**Regulation 25
Town and Country Planning
(Environmental Impact Assessment) Regulations 2017
Request for Further Information**

**Noise & Vibration Impact Assessment for
Proposed Sand & Gravel Quarry
at**

**Land at Bow Farm
Bow Lane
Twyning
Tewkesbury
Gloucestershire**

Application Number: 19/0081/TWMAJM (District Ref: 19/1231/CM)

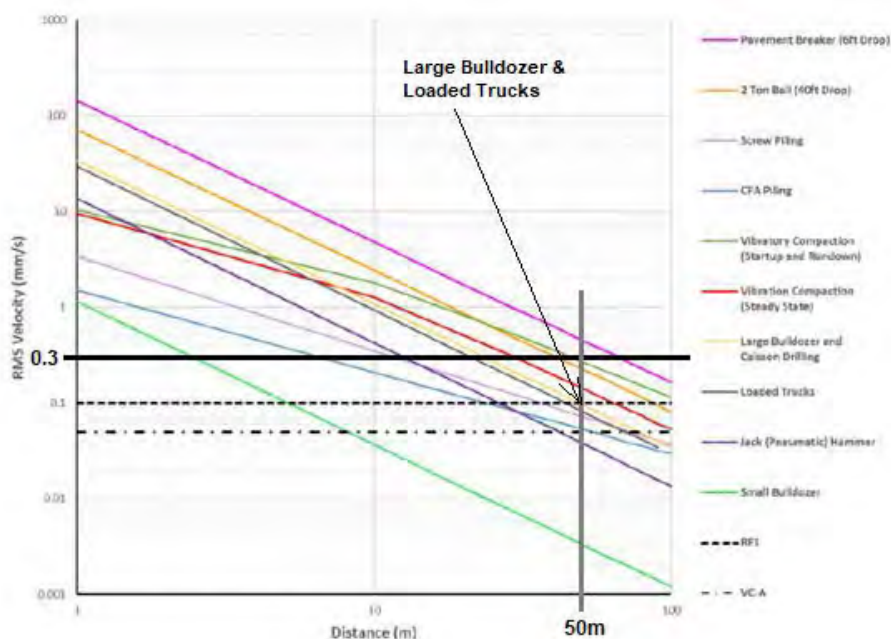
Q1. Further information is requested in relation to vibration and the impacts upon sensitive receptors, and in particular the impact of vibration upon the heritage asset of Puck Cottage (Grade II Listed Building).

The closest approach to Puck Cottage (i.e. during the construction of earth mound screening) is circa 50m (this being the closest of all receptors). The following graph provides additional information on vibration levels from this source of vibration. The 50m distance and the perceptible level of vibration (0.3mm/sec PPV) is indicated on the graph (as black & grey solid lines). The level of vibration for a large bulldozer (light orange thin line) and loaded trucks (thin grey line) is shown to be circa 0.1mm/sec. This is below the level of perceptibility and therefore insignificant and a **negligible** impact magnitude and **neutral** effect on the property.

The evidence shows that plant used on site with the maximum likely generated ground vibration, does not produce any significant levels of vibration. For any cosmetic damage to occur this would mean that vibration levels would need to reach levels of around 5mm/sec and maximum levels predicted are insignificant.

Bow Farm property (owned by the applicant) is circa 25-30m from the nearest mobile plant activity and during earth mound screening works, the predicted maximum vibration levels are shown to be just below 0.3mm/sec, which again is insignificant.
